Access Compliance Report

Public Rights-of-Way

(Pedestrian Signals)

Intersection ID: N/A	Main Street:	Cross Street: N/A	Location: N/A
ADA ID: 639CAB499EDC	Signal Type: One Push Button-Non APS	Overall Compliance: No	Severity Score: BTN 1: N/A BTN 2: N/A No BTN: N/A
Codes/Mitigation Info/Possible Solution		Field Measurements/Component Compliance

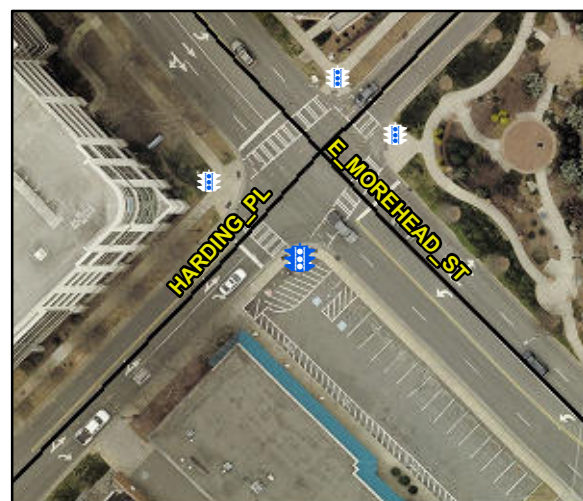
PROW/ADA: R406.2

Possible Solutions: Provide Push Button Extension.

Total Cost: \$ 500.00
